Re: Certification Submittal for Final Building Certificate of Occupancy for
Lot 29, Alameda Business Park, [C-16 / D6II]
8724 Alameda Park Dr.
Engineer's Stamp Dated 06/19/07

**Re: Alameda Business Park-lot 29, 8724 Alameda Park Dr,
Approval of Permanent Certificate of Occupancy (C.O.)
Engineer's Stamp dated 10/24/05 (C16/D006II)
Certification dated 6/19/07**

**Re: Alameda Business Park, Lot 29 Grading and Drainage Plan
Engineer's Stamp dated 10-24-05 (C16/D6II)**

Re: Grading & Drainage for Lot 29, Alameda Business Park, ZAP C-16
Engineer's Stamp Dated June 8, 2005

**RETAINING WALL DETAIL
FOR
LOT 29, ALAMEDA BUSINESS PARK**

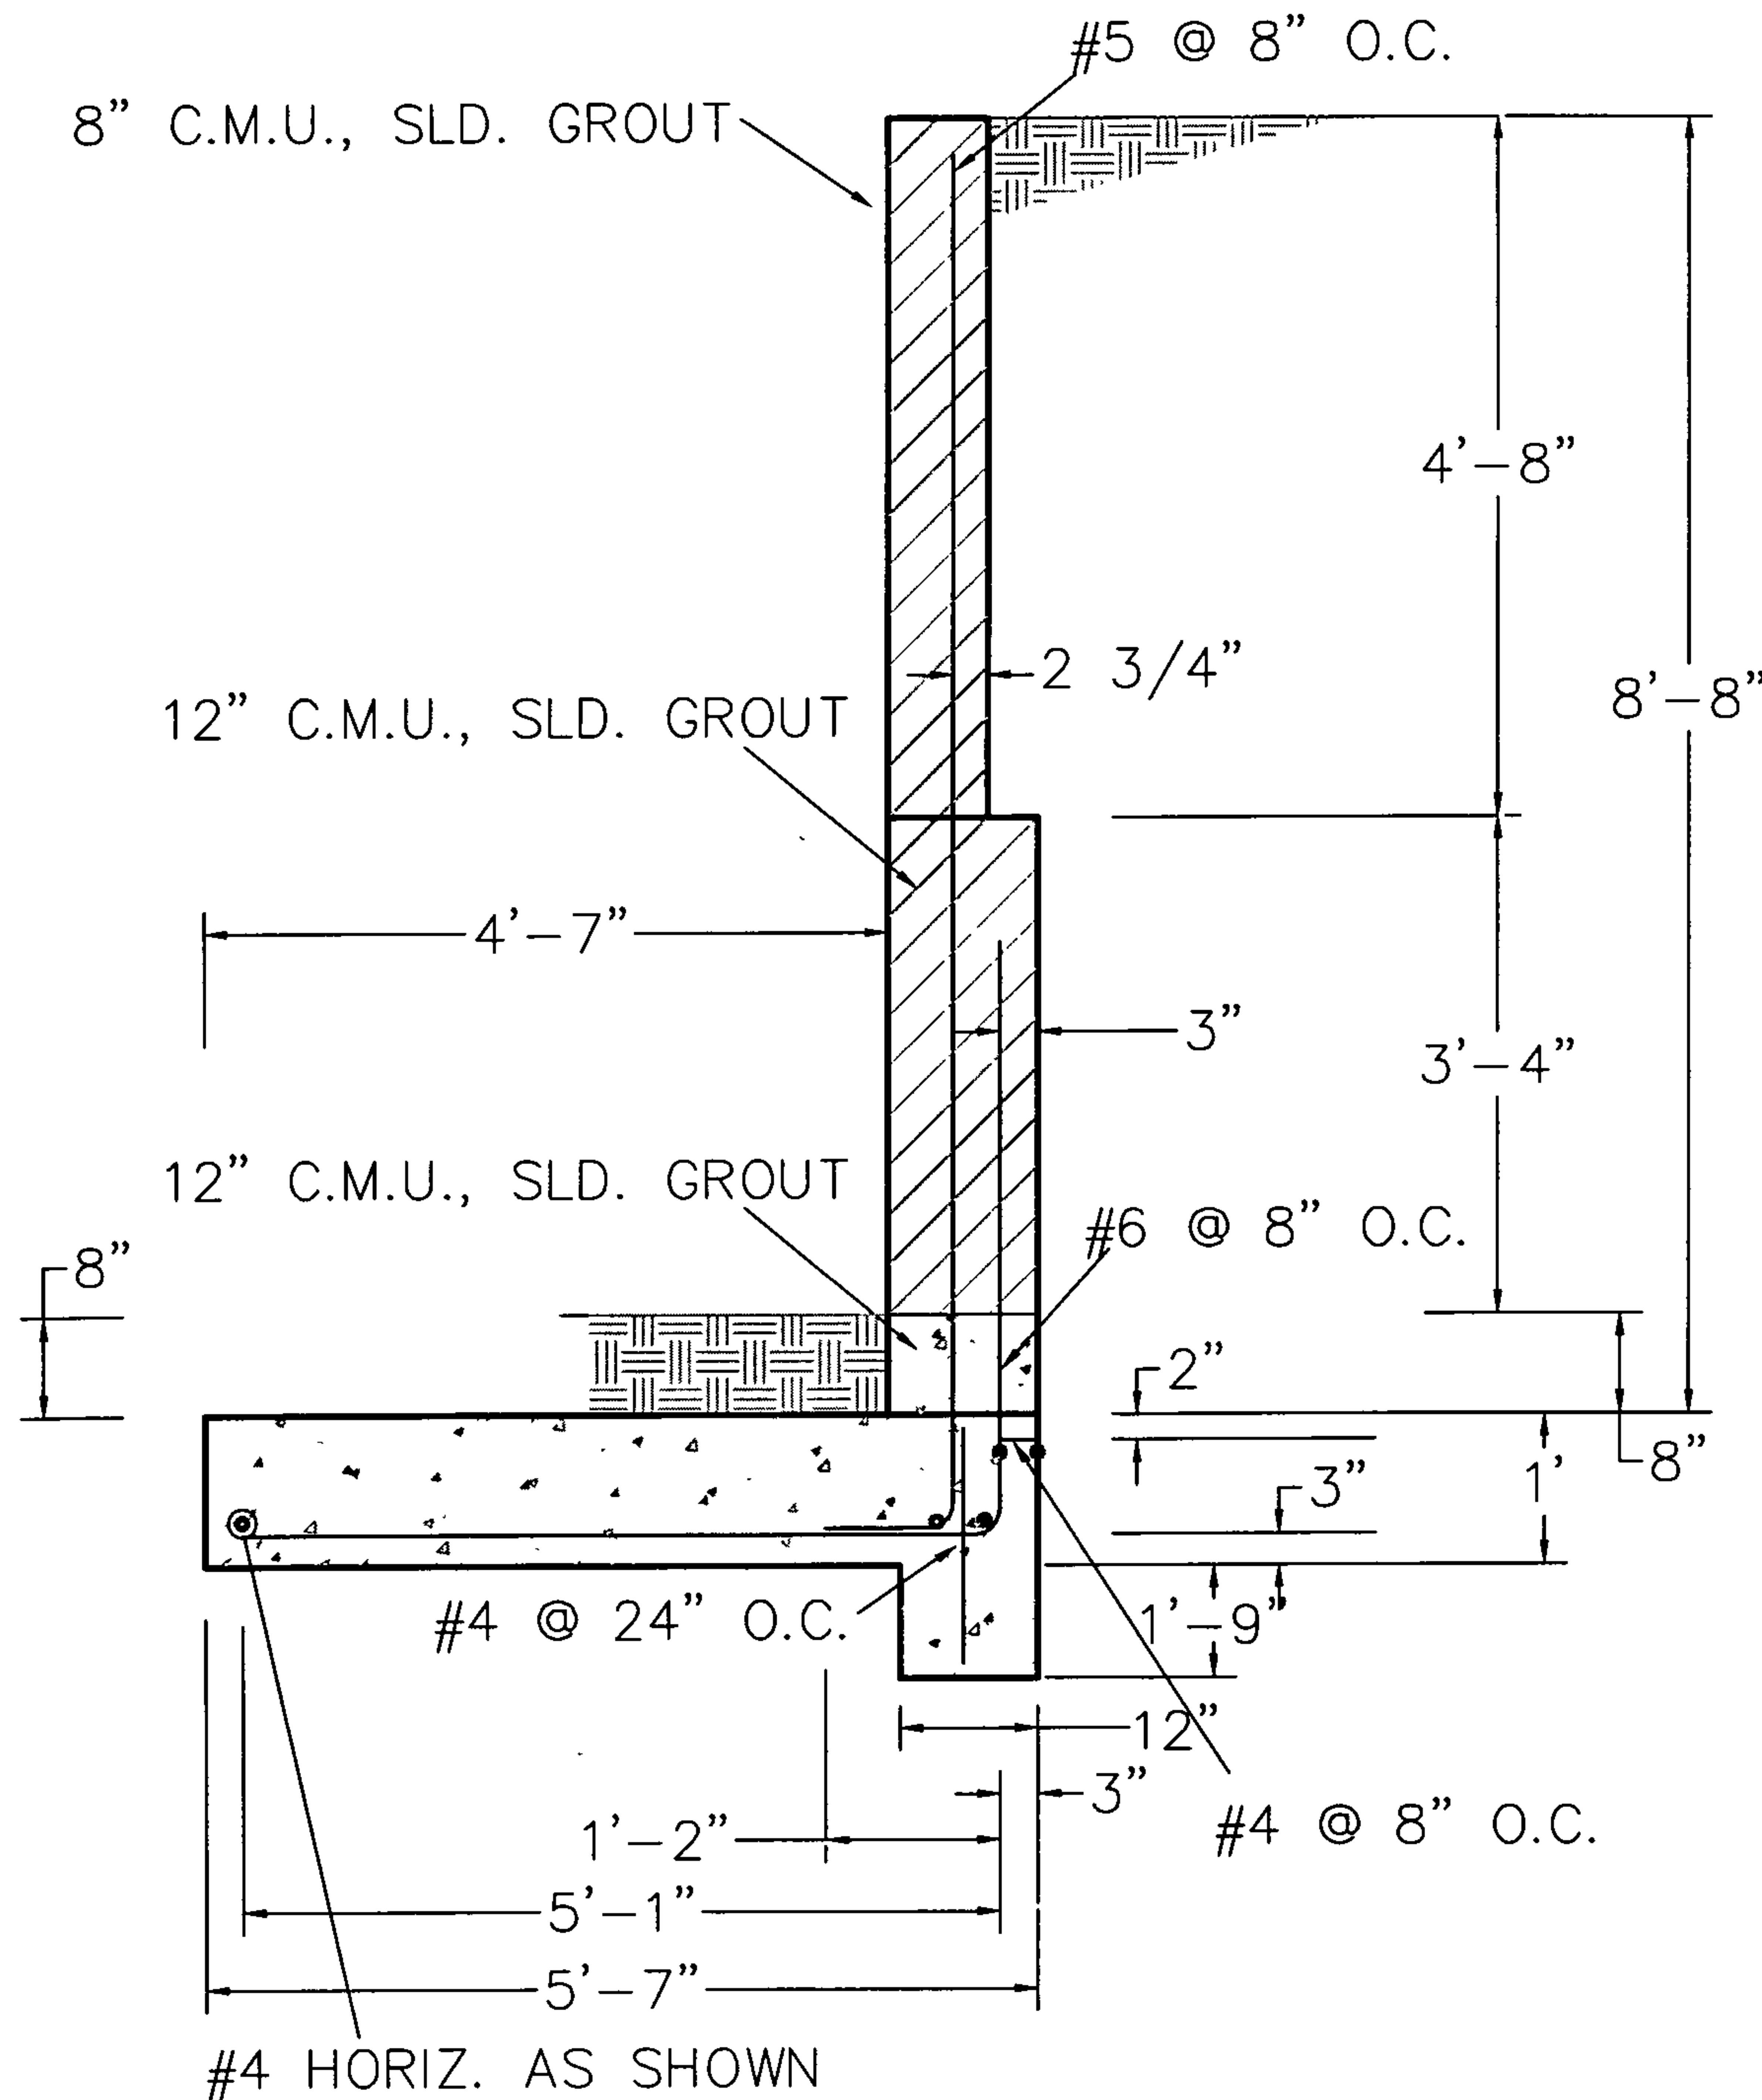
I am sending this correspondence in response to our conversation on Friday, January 27, and your voice mail message on Monday, January 30. Due to the expense of the previously designed retaining wall, you requested a variance in the 3-foot saturation assumption in the wall calculations with additional weep holes. AMAFCA will not allow this variance. The North Diversion Channel is the major flood control facility serving this area of town, and we cannot allow a lesser design standard in order to save a developer money. An option for the owner is to stay out of the 80-foot AMAFCA slope easement and allow the existing slope to remain. We will be happy to meet with you and your client to discuss this matter further.

AMAFCA does not approve release of building permit until we receive concurrence from the Corps of Engineers. I supplied you a copy of the Special Warranty Deed, Document No. 08892147, which states:

I have received the required approval from the U.S. Army Corps of Engineers for construction within the AMAFCA slope easement adjacent to the North Diversion Channel. AMAFCA approves release of building permit. The retaining wall within the easement will be constructed per the calculations dated October 17, 2005, and AMAFCA will inspect prior to release of Certificate of Occupancy.
